A46 Coventry Junctions (Walsgrave) Scheme Number: TR010066

8.17 Applicant's Comments on Local Impact Reports

APPLICANT'S COMMENTS ON LOCAL IMPACT REPORTS

Rule Number	Rule 8(1)(j)
Planning Inspectorate Scheme Reference	TR010066
Application Document Reference	TR010066/EXAM/8.17
Author	A46 Coventry Junctions (Walsgrave) Project Team, National Highways

Appendix 1 - Section Through Centre of Smite Brook Culvert

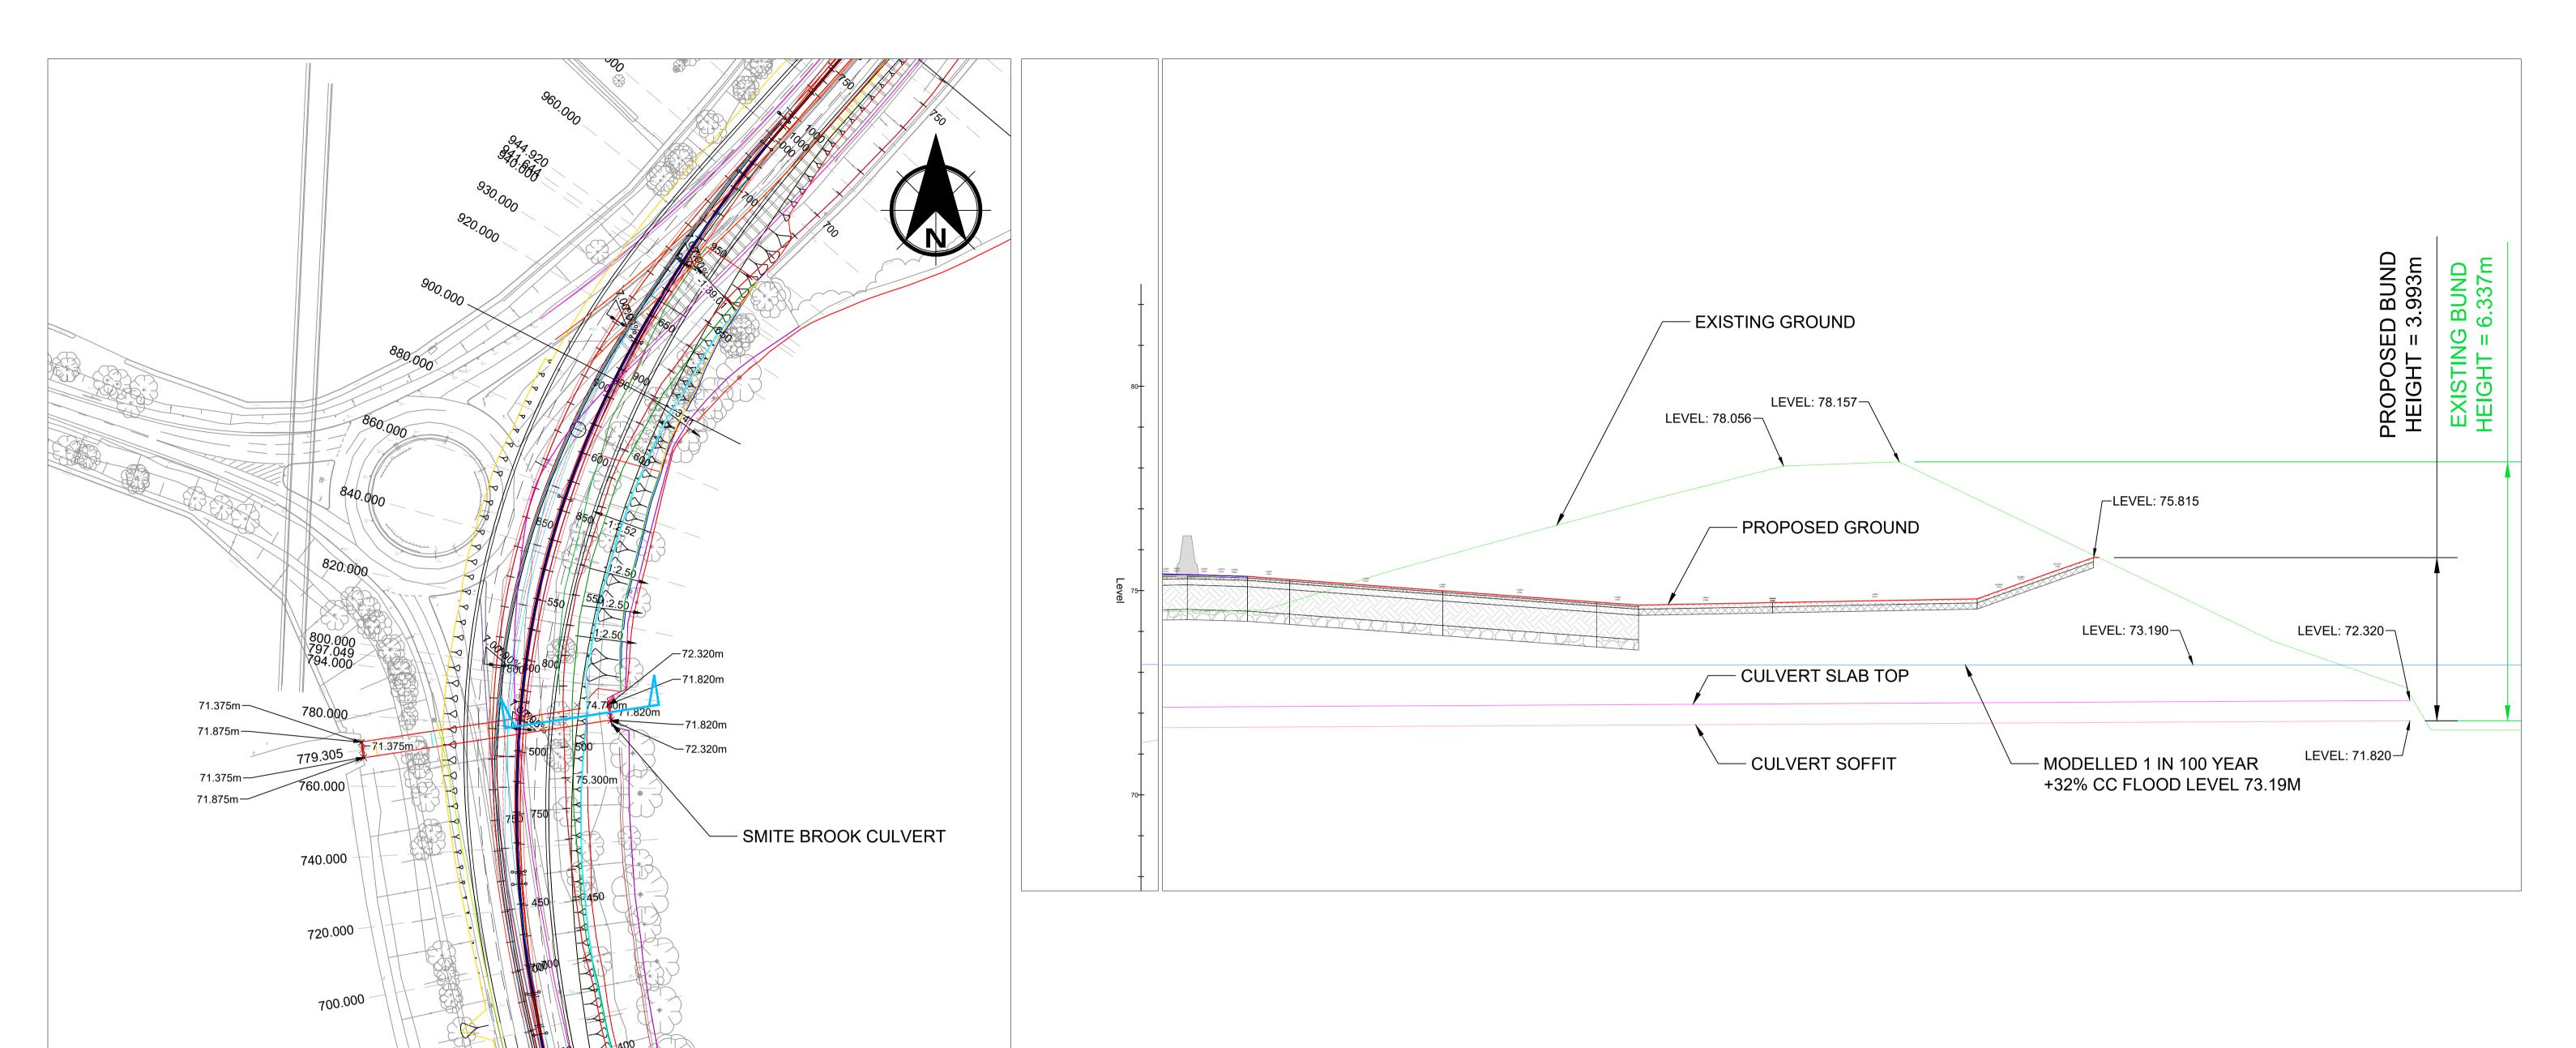
8.5	The Council had highlighted, during discussions with the applicant, some concern with the height of the embankment at the location of the Smite Brook culvert under the A46. Following this the applicant provided a cross section on the 25th April 2025 which showed a greater proportion of the bund remaining than was initial understood by CCC. The section shows over half the bund height above the culvert soffit being retained. The section shows the top of the bund will be 3.993m above the culvert soffit, as currently the bund is 6.337m high, which places the proposed bund 0.827m higher than the current halfway point. The halfway point is the critical level that was discussed with the applicant and is substantially above the flood levels observed by the Council (Jan 2024 and Jan 2025). This plan has provided comfort to the Local Lead Flood Authority Officer of the Council.	The Applicant notes Coventry City Council's position and has attached the cross section referenced by Coventry City Council in their response to aid the ExA's understanding of Coventry City Council's position. This cross-section is included in Appendix A of this document: Section Through Centre of Smite Brook Culvert.
